• **NOISE—"WHINE" OR "HOWL" NOISE FROM TRANSMISSION AT START-UP—TEMPERATURES BELOW 4 C (40 F)—VEHICLES EQUIPPED WITH 5R55W TRANSMISSION—PRODUCED 11/13/2000 THROUGH 6/15/2001 ONLY** • **TRANSMISSION—5R55W—"WHINE" OR "HOWL" NOISE FROM TRANSMISSION AT START-UP—TEMPERATURES BELOW 4 C (40 F)—PRODUCED 11/13/2000 THROUGH 6/15/2001 ONLY**	**Article No. 01-14-2**

FORD: 2002 EXPLORER

MERCURY: 2002 MOUNTAINEER

Figure 1 - Article 01-14-2

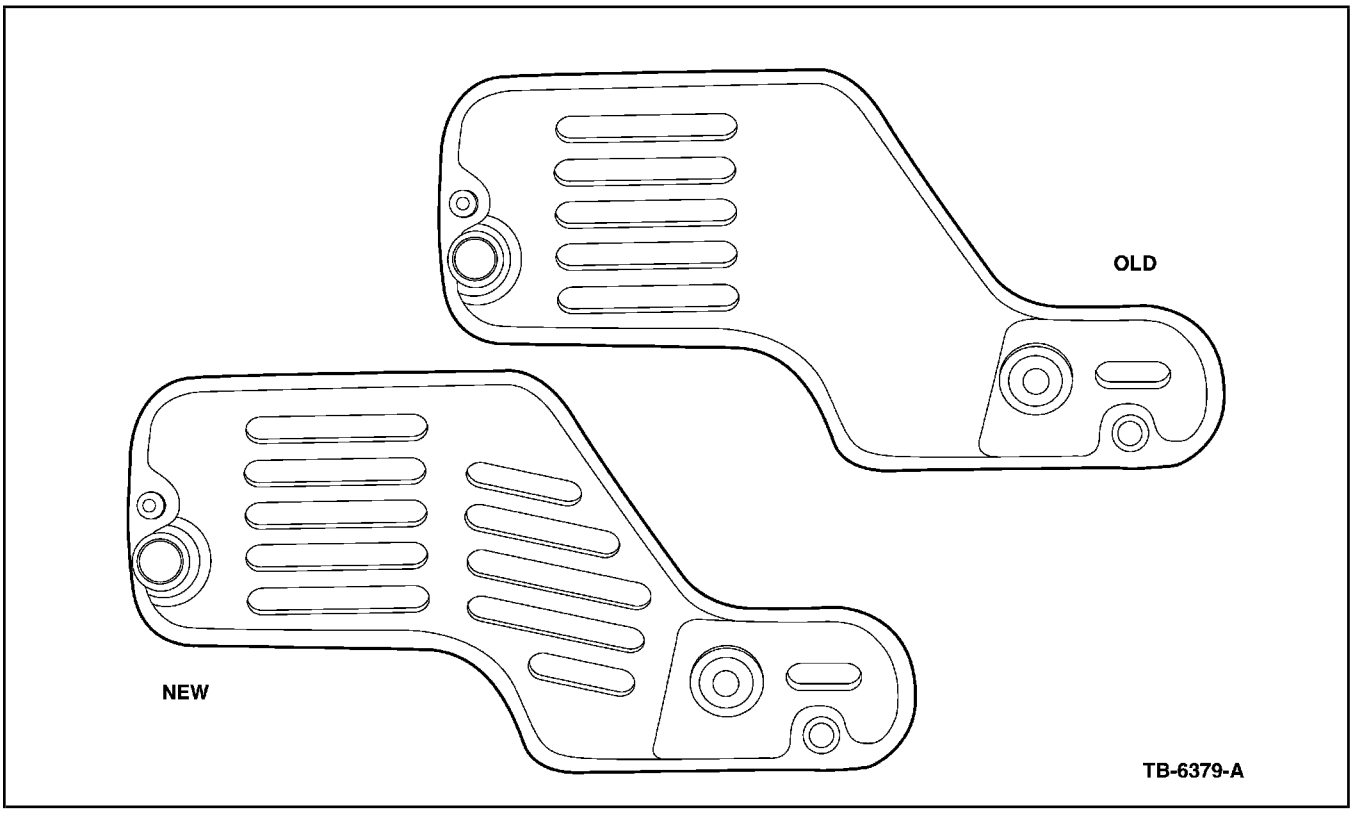
Some vehicles, built prior to 6/15/2001, may exhibit a "whine" or "howl" noise during cold starts at temperatures below 4° C (40°F). This noise may be caused by the transmission fluid filter.

1. Raise vehicle on a hoist.
2. Drain the fluid from the pan.
3. Remove the pan and gasket.
4. Replace the original filter with the new service filter 1L2Z-7A098-AC (Figure 1).
5. Clean the pan.
6. Reinstall the fluid pan gasket and pan. Tighten the screws in a crisscross pattern to 11 N•m (8 lb-ft).
7. Add fluid and adjust to the proper level, refer to the workshop manual procedure, Fluid Level Check.
8. If the noise is still present after the fluid filter has been replaced, follow normal diagnosis for noise concerns using the Diagnosis by Symptom Charts in the Workshop Manual (Section 307-01).
